CITY COUNCIL MEETING AUGUST 16, 2022

N.2 DISCUSSION AND POSSIBLE ACTION REGARDING THE CITY'S LIVING STREETS POLICY, THE BEACH CITIES HEALTH DISTRICT'S STREETS FOR ALL PROGRAM AND RELATED GRANT OPPORTUNITIES, AND THE PREPARATION OF A LIVING STREETS DESIGN MANUAL

Re: Living Streets

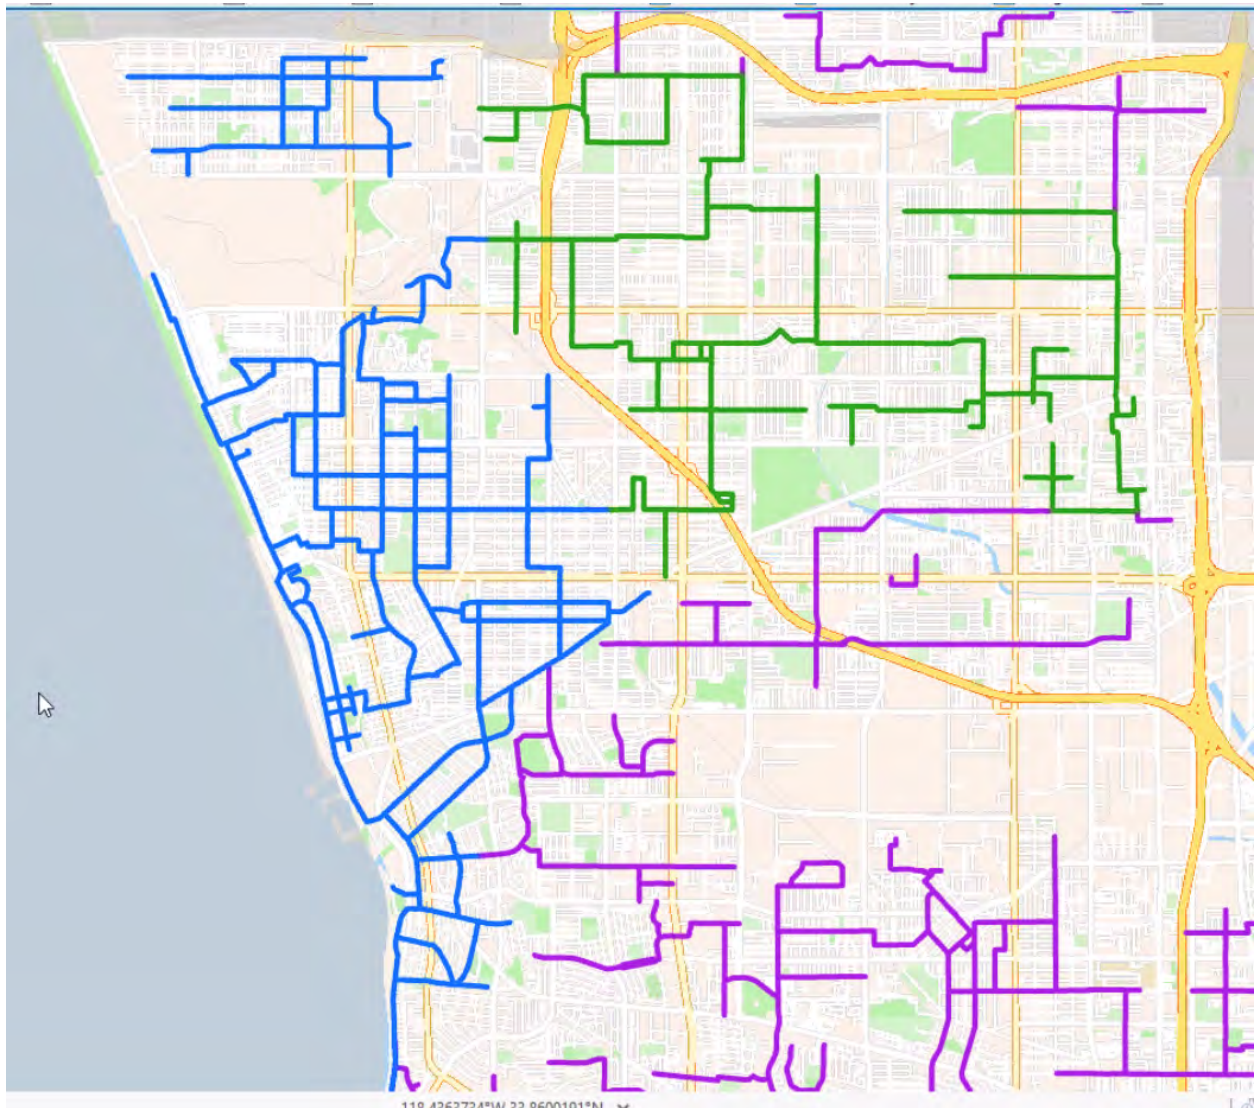
Manhattan and Hermosa Beaches' networks are substantially denser than that of Redondo Beach. Compare North Redondo Beach with East Manhattan Beach. In EMB, schools and parks are surrounded and connected by a dense and redundant network that allows travelers to avoid steep hills or go directly if they (or their electric motor) is strong enough. Redondo Beach's network doesn't touch many of the schools, much less surround them. We won't qualify for [Safe Routes to School funding](#)¹ (SRTS) if our plan doesn't include Safe Routes to School.

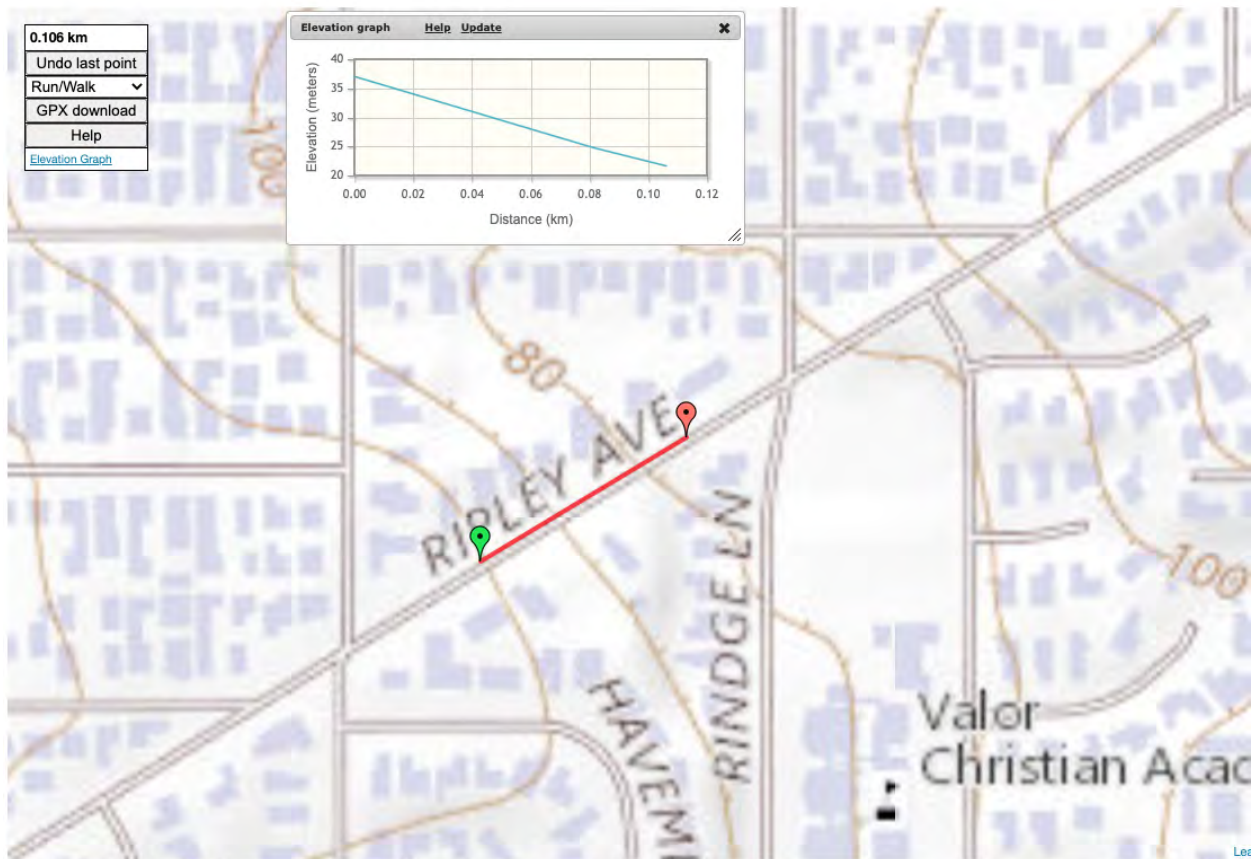
Thus, our bike network needs to be designed with hills in mind. Some users may prefer a flatter route. Others may prefer a more direct route. We should serve a wide variety of road users, for different trip purposes. We need to plan for an alternative to Ripley, with its 15% grade hill between Blossom and Rindge.

Inglewood Avenue is a barrier for micro mobility because it's disconcerting to travel on such a busy and fast street, but there are so few ways to cross it with a traffic signal. Put a sidewalk level 2-way bike path on the west side of Inglewood on the short block between Grant and Ripley (shown in blue). They install a scramble light at Grant and Ripley so that cyclists can clear the curve east of Inglewood and the merge area west of Inglewood before motorists.

Drivers routinely drive into the painted bike lane on the curve as they pick up speed going downhill under the railroad bridge. Put some concrete k-rails through the curve and bridge (shown in red).

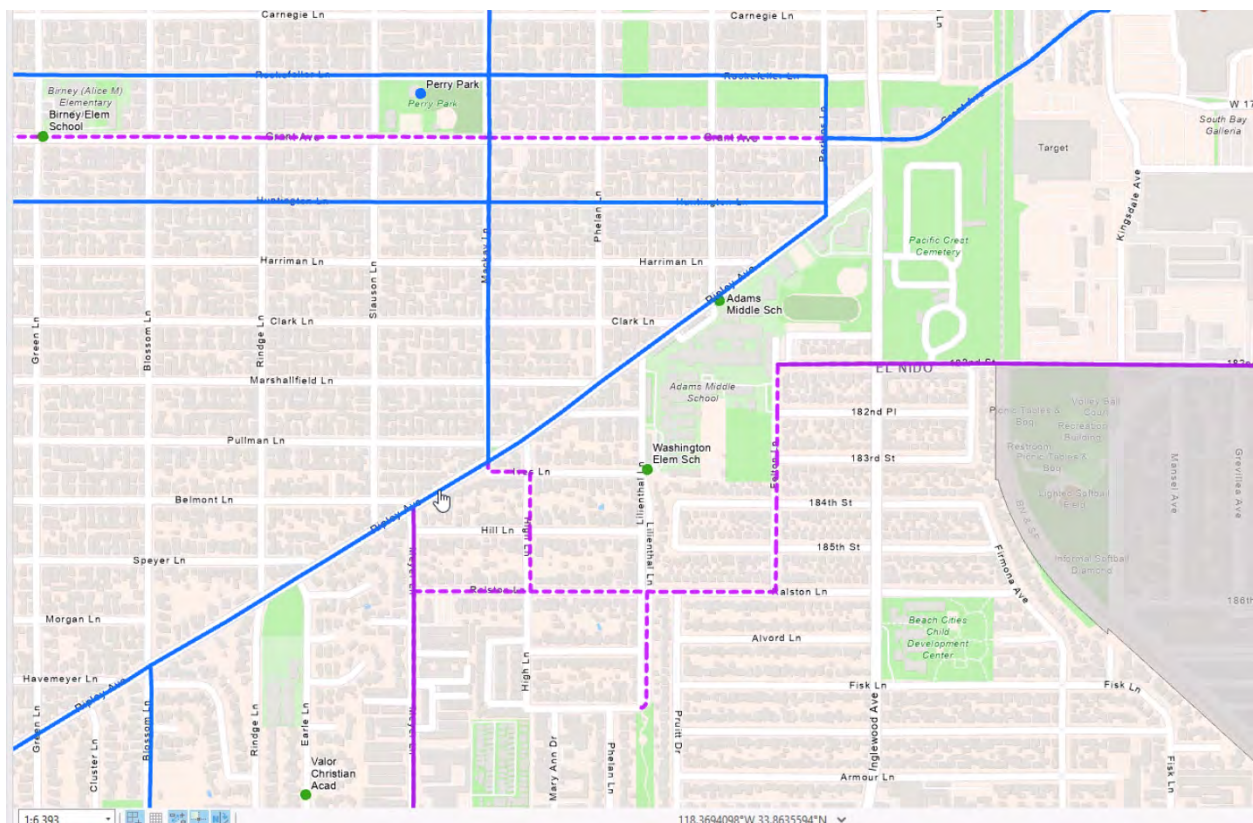
The removal of Grant from the LTN is also highly concerning. Until we build out protected bike lanes on Artesia, Grant is the most level East-West route through a hilly region with a maximum grade of 3% between Inglewood and Aviation. Deletion of Grant (dashed purple) from the LTN and substitution of Rockefeller and Huntington is insufficient.

Westbound cyclists on one-way Rockefeller would need to climb 2 hills of 4% and 6% grade (and stop at 12 stop signs) instead of one hill on Grant of 3% grade. Eastbound cyclists on Huntington would need to climb 3 hills of 6%, 5.5% and 4% grade (and stop at 11 stop signs). Grant has 6 traffic lights that heavily favor East-West travel, so it is possible to bicycle the entire length with 0-1 stops vs 11-12 on Rockefeller or Huntington.

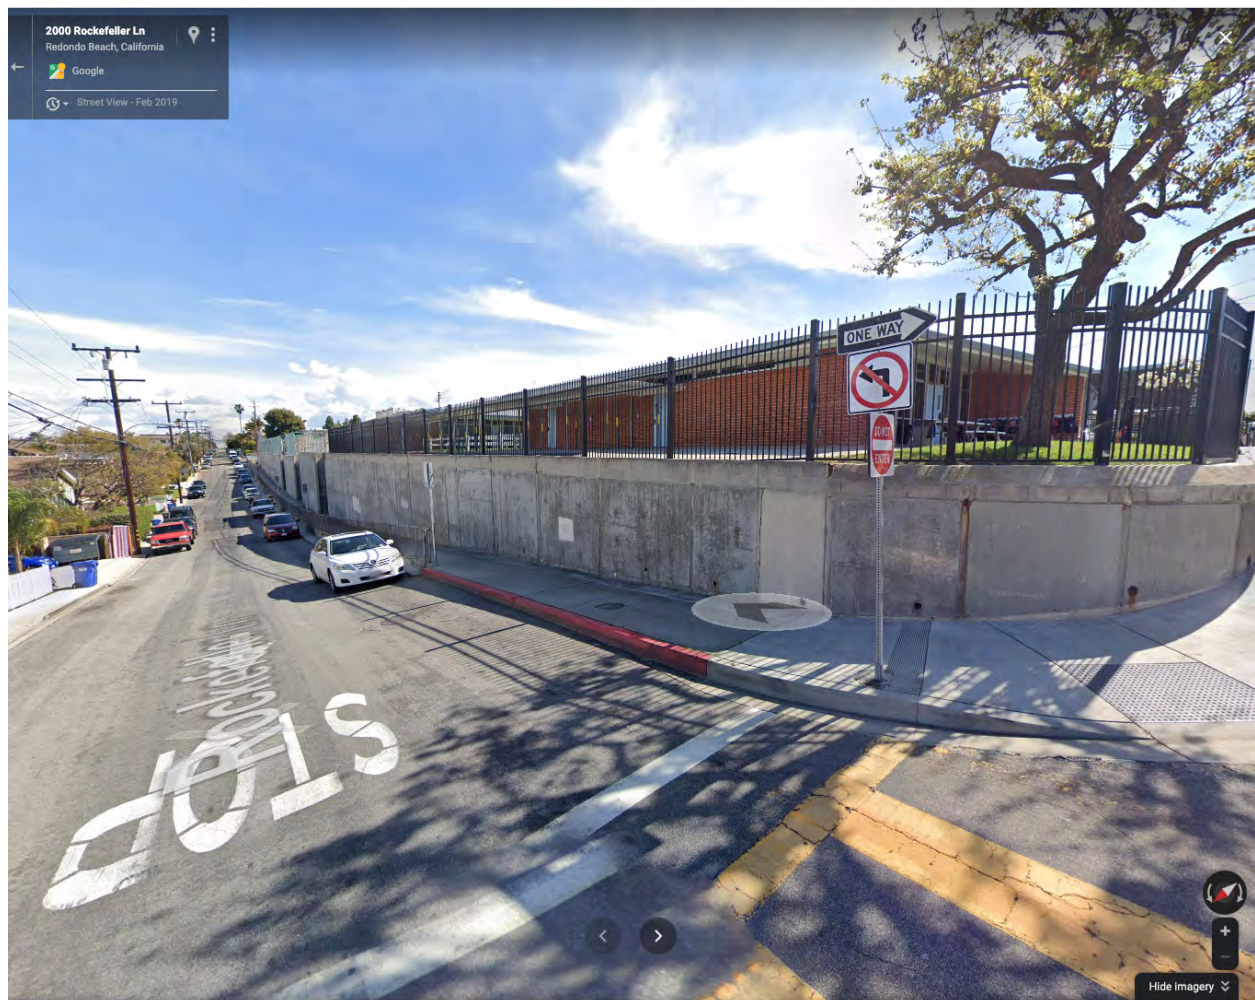
The entrance to Birney ES is on Grant, not Rockefeller. Don't put the kids in the bottom of a valley and make them climb another 20 foot hill before school.

Rockefeller and Huntington are one-way streets that allow parking on both sides. Bicyclists are trapped in the middle with nowhere to move when a car comes up behind them. Motorists can easily pass bicyclists on Grant, which has a wide bike lane.

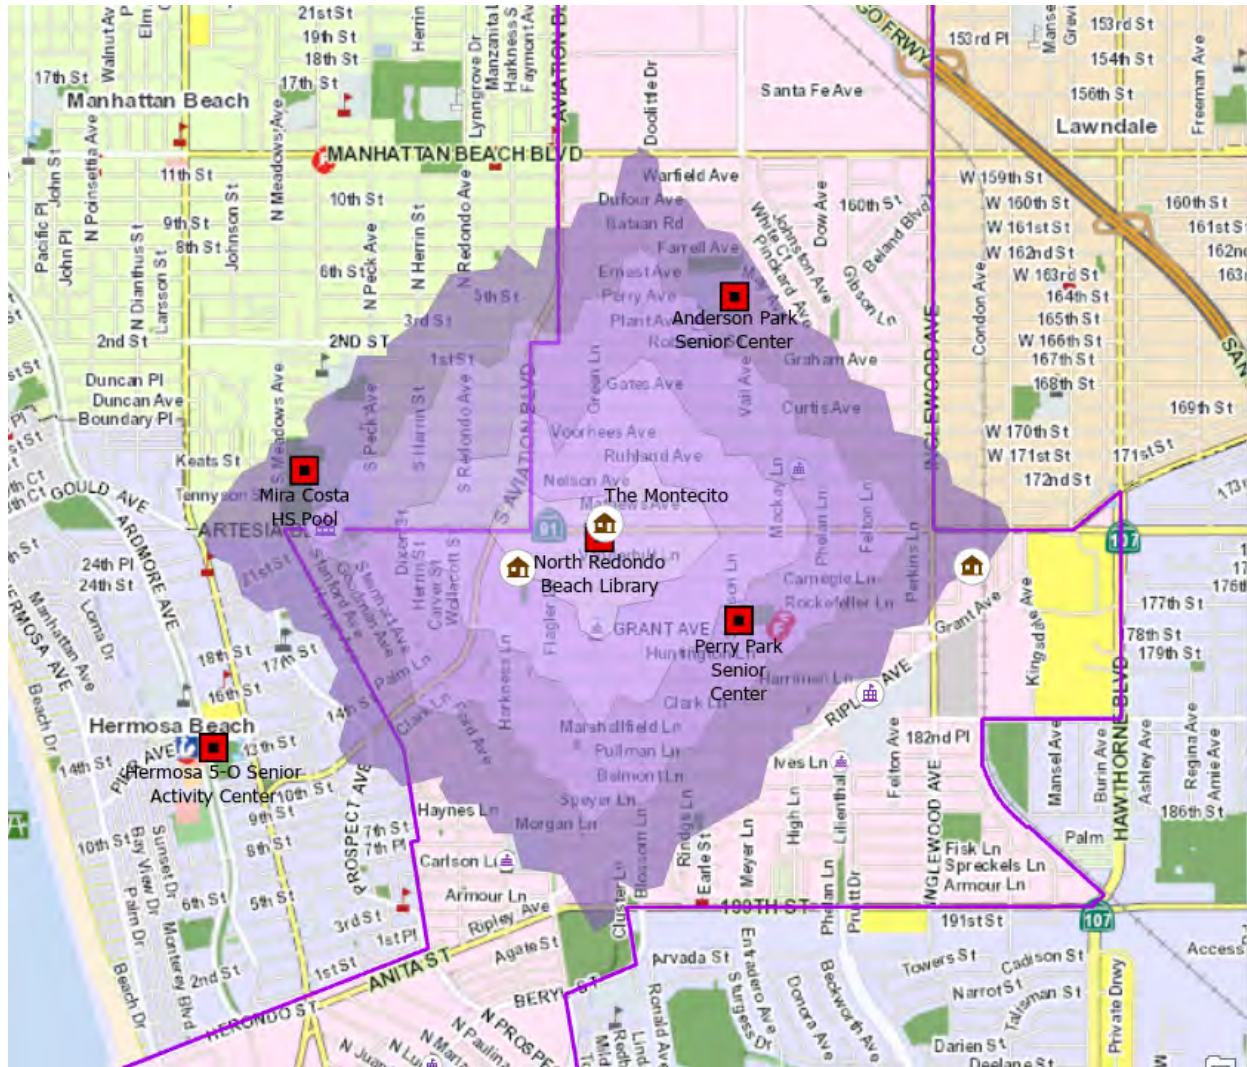
Another serious issue is the lack of a legal eastbound crossing of Aviation. Redondo Beach students who live north of Artesia and attend Mira Costa High School can cross Aviation westbound on Robinson, but cannot return. Both Plant and Robinson are one-way streets heading westbound. If we want bicyclists to obey traffic laws, we need to enable them with supportive circulation design.

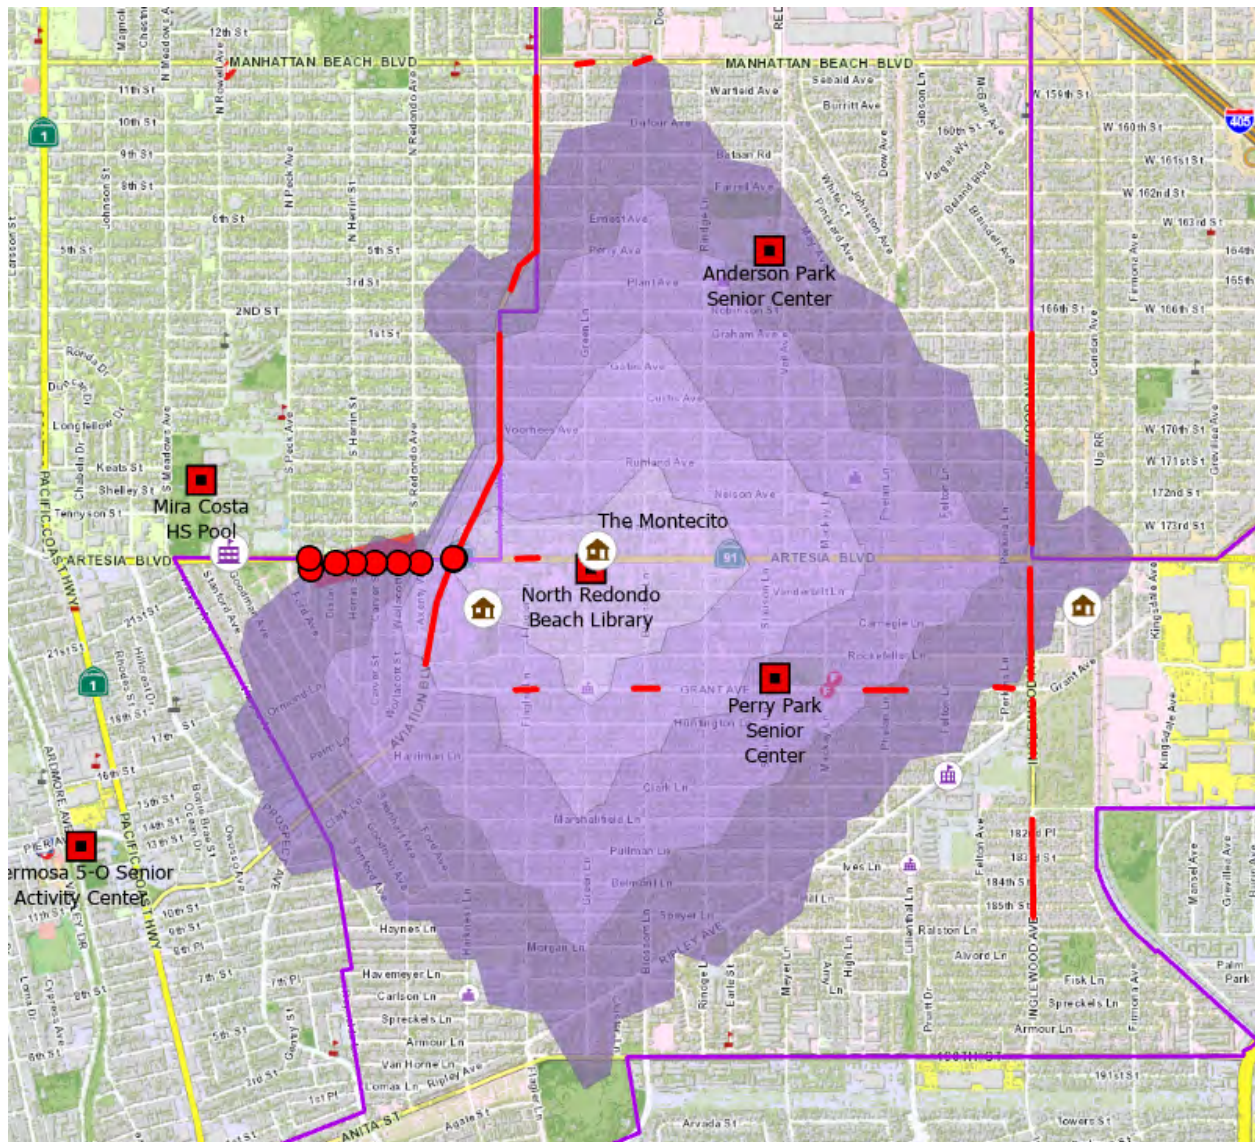
But, if they can't cross the recently widened road, then their world shrinks. They can no longer reach senior aqua aerobics or listen to their grandchildren play sports or music at Mira Costa.

Single curb ramps on fast and busy streets put people at risk. For instance, the curb ramp at Artesia and Aviation forces seniors with walkers or in wheelchairs to push a button aligned with the crosswalk, then walk to the curb ramp and back onto the crosswalk. We can help seniors stay active if we provide double curb ramps on wide arterials that align with the crosswalks.
